The Friends of Platt Fields
registered charity 1086533

Planning ref: 129020/FO/2020

We wish to object to the above referenced planning application on behalf of the Friends of Platt Fields. The objectives of the Friends are:

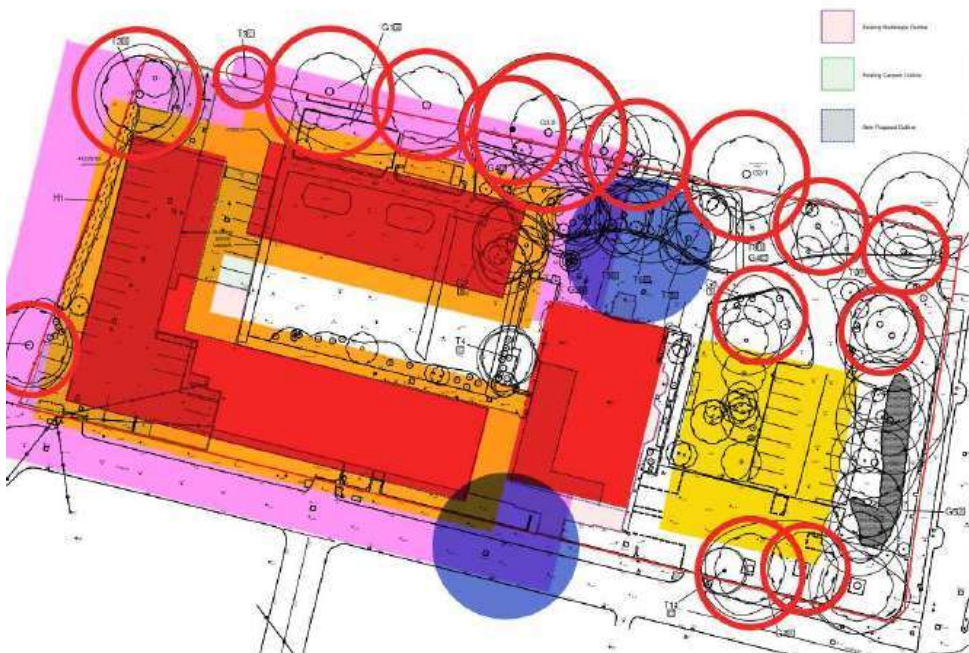
1. **Loss of light or overshadowing** - The proposed tower is more than double the height of the trees in the park on the northern boundary of the site. This will seriously overshadow the park grounds and deprive the vegetation of light to the detriment of the gardens and existing trees. The height of the tower will also ruin what is currently a complimentary tree-lined boundary to the park, being much to the original design of the park when it was purchased over one hundred years ago. There is no assessment of the light pollution from the 13 storey block over the park.

1 Threatened trees highlighted with a red circle. Note that most are outside the site boundary, in the park.

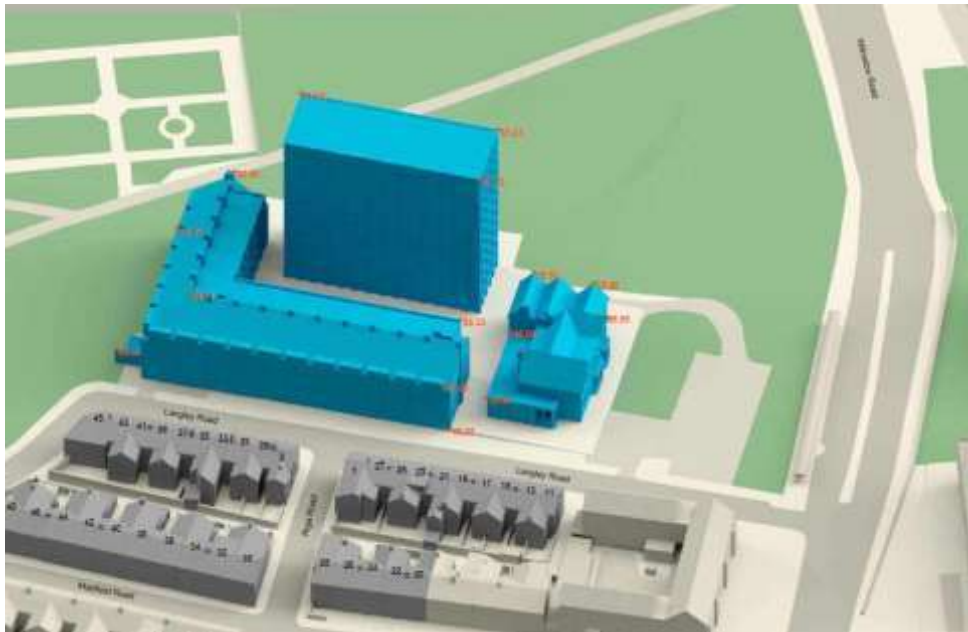
2. **Loss of trees** on the boundary *inside* Platt Fields particularly **six mature sycamores**. The height and proximity of the proposed buildings to these trees will likely lead to their loss. A building of such size will have deep and damaging foundations which will cut through the root ball of those trees, and failing that the loss of light from a building so close and over twice the height will block out too much sunlight.
